LLNL-AR-454953

Explanation of Significant Difference for Ground Water Nitrate Treatment at the Building 829-Source Treatment Facility Lawrence Livermore National Laboratory Site 300

December 2010

Figure 6. Modified B829-SRC treatment system configuration with nitrate ion-exchange columns.

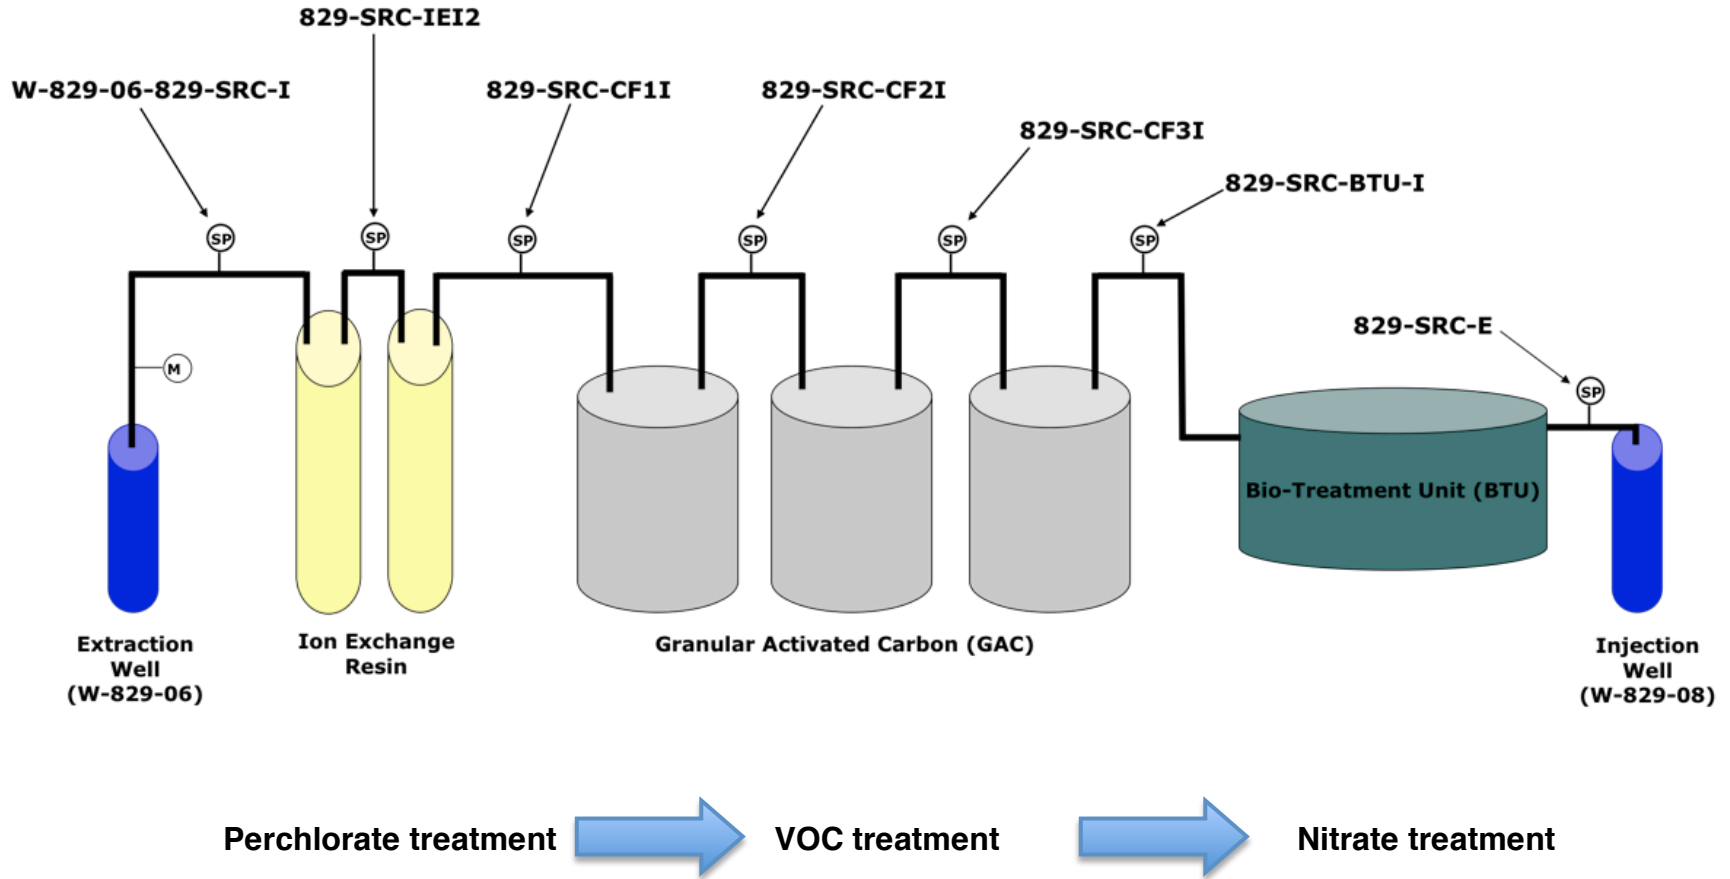
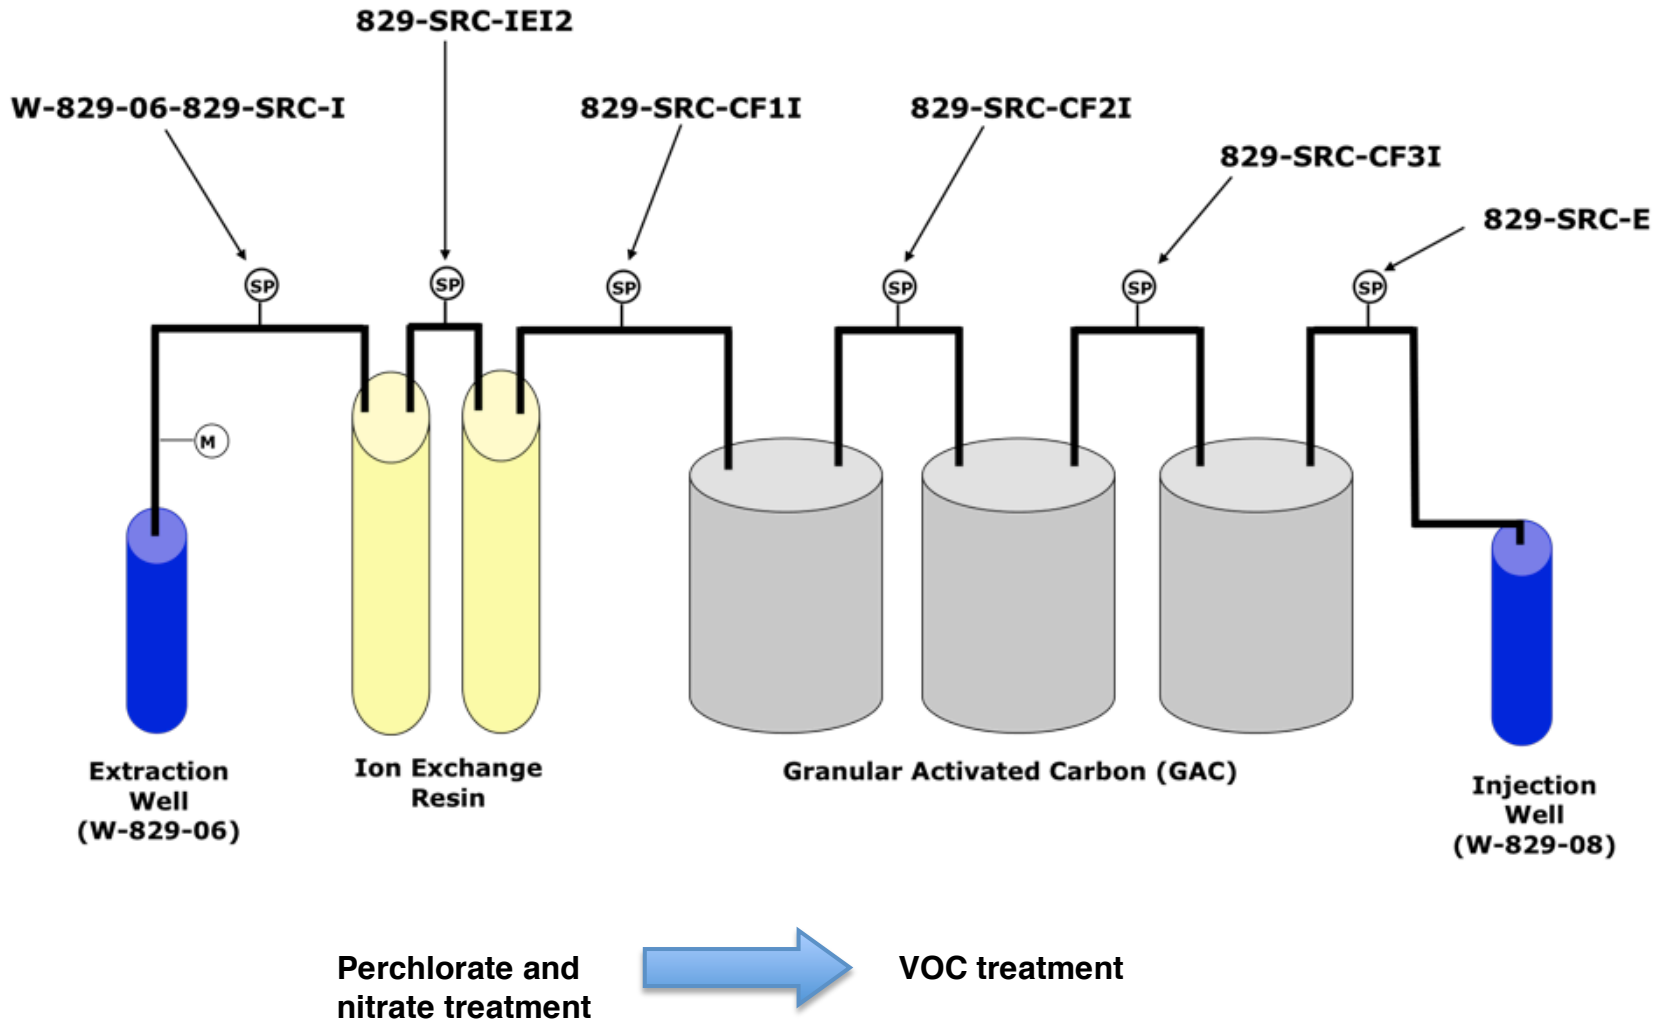
This ESD documents the removal of the BTU and the use of the existing ion-exchange technology already in place at the B829-SRC treatment facility to continue to remove nitrate from extracted ground water because:

1. The ion-exchange columns are effectively removing the nitrate to meet effluent discharge limits, rendering the BTU unnecessary,
2. The BTU is impractical under the operational conditions at B829-SRC.
3. Elimination of the BTU is expected to increase the overall operational efficiency of the B829-SRC treatment facility, and decrease operation and long-term maintenance (O&M) efforts.

The proposed B829-SRC treatment facility configuration is shown in Figure 6. The ion-exchange resin used for perchlorate removal is an anion-exchange resin that also effectively removes nitrate. The resin has a higher affinity for binding perchlorate, so nitrate will be released as the perchlorate is loaded. There are two ion-exchange columns in series, and routine monitoring for both nitrate and perchlorate will be performed between columns to ensure change-out of columns is performed to meet effluent limitations for perchlorate and nitrate. When breakthrough of nitrate or perchlorate occurs after the first ion-exchange column, the first column will be removed, the second column will be moved to the first position, and a new column would be placed in the second position. The ion-exchange technology has been demonstrated to be effective, and requires relatively little maintenance. No changes to the size or number of ion-exchange columns are needed to remove nitrate and perchlorate to meet effluent limits.

Item	Existing B829-SRC	Modified B829-SRC	Change from Final Site-Wide ROD
Ground water extraction well	W-829-06	W-829-06	No
Flow rate	5-10 gpd	5-10 gpd	No
VOC Treatment	3 in-series GAC units	3 in-series GAC units	No
Perchlorate Treatment	2 in-series ion-exchange units	2 in-series ion-exchange units	No
Nitrate Treatment	Biotreatment unit	2 in-series ion-exchange units	Yes
Effluent Limitations	VOCs: 0.5 µg/L Perchlorate: 4 µg/L Nitrate: 45 mg/L	VOCs: 0.5 µg/L Perchlorate: 4 µg/L Nitrate: 45 mg/L	No
Discharge method/location	Treated effluent injected into well W-829-08	Treated effluent injected into well W-829-08	No
Facility effluent monitoring	Treatment facility effluent is monitored after the BTU.	Treatment facility effluent will be monitored after the GAC units.	No; not specified in ROD

Figure 5. Nitrate (as NO₃) concentrations in the influent and effluent to the B829-SRC Ground Water Treatment System (GWTS) ion-exchange (IX) columns.

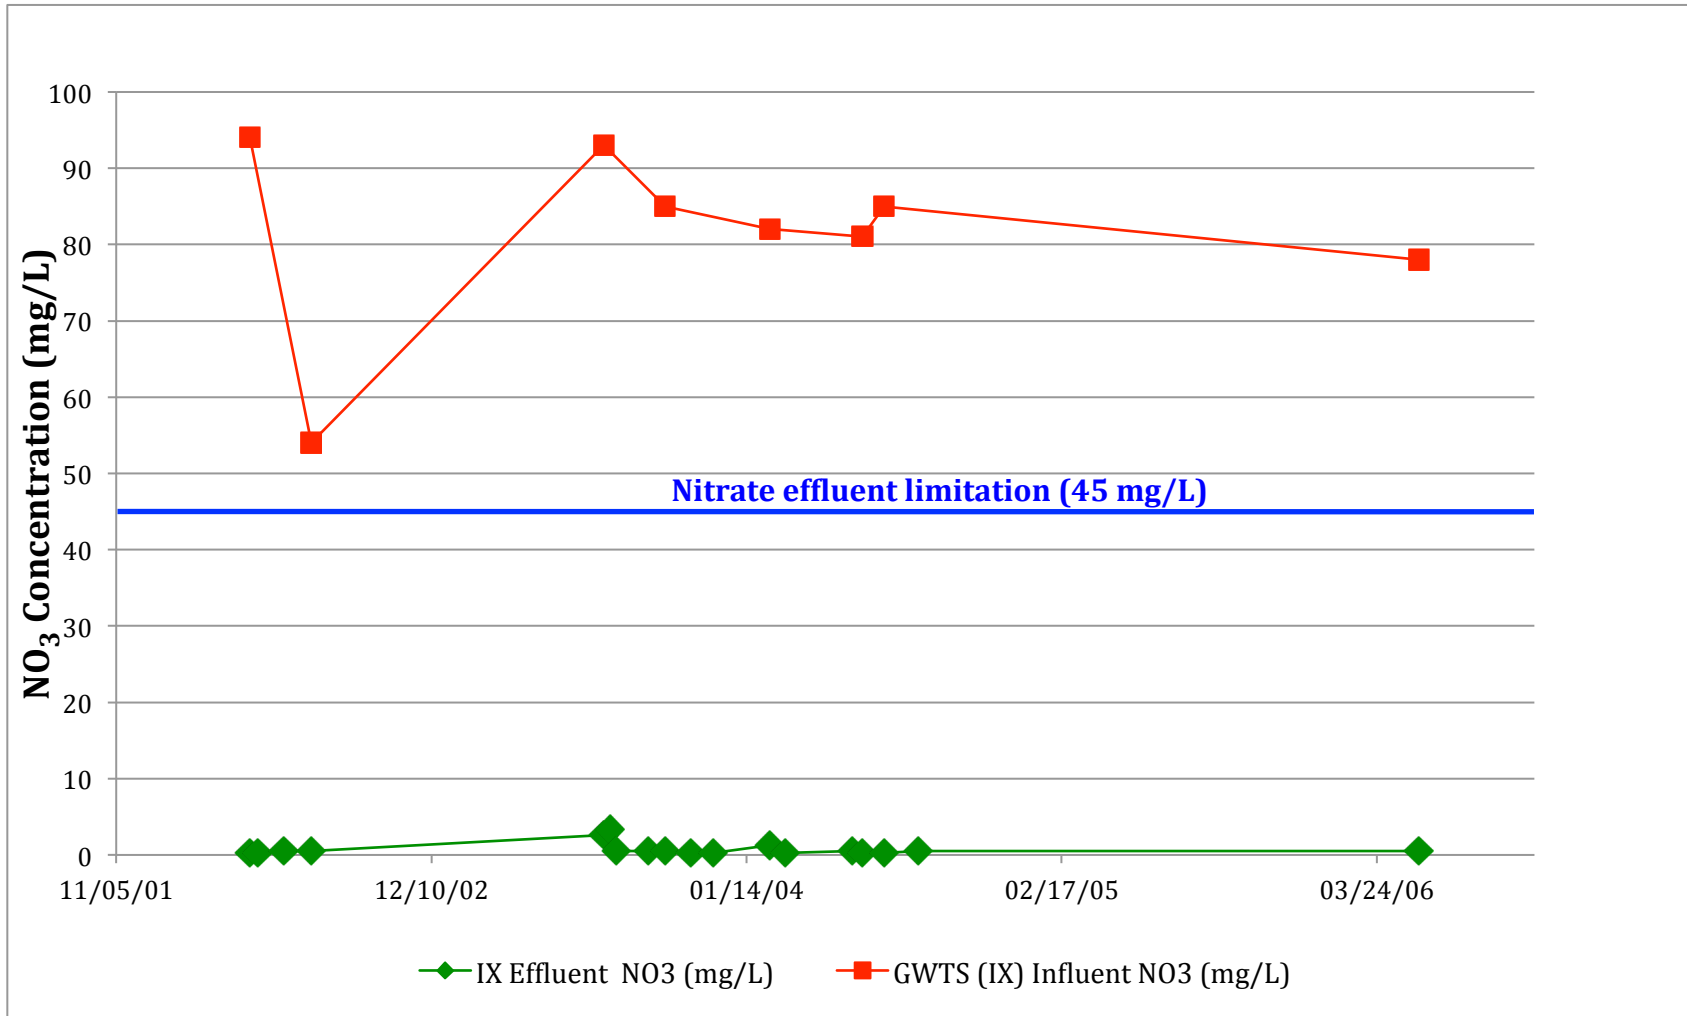
Table 1 and Figure 5 present nitrate analytical data for water samples collected at sample ports at the influent to and effluent from the ion-exchange resin columns at the B829-SRC treatment facility. These data demonstrate that the ion-exchange resin effectively reduces nitrate concentrations to significantly below the 45 mg/L nitrate effluent limitation. Because the BTU is located after the ion-exchange resin columns, the decrease in nitrate concentration to near or below the 0.5 to 1 mg/L practical quantitation limit is solely the result of nitrate treatment by the ion-exchange resin. Therefore, the BTU is not necessary to meet discharge limits for nitrate.
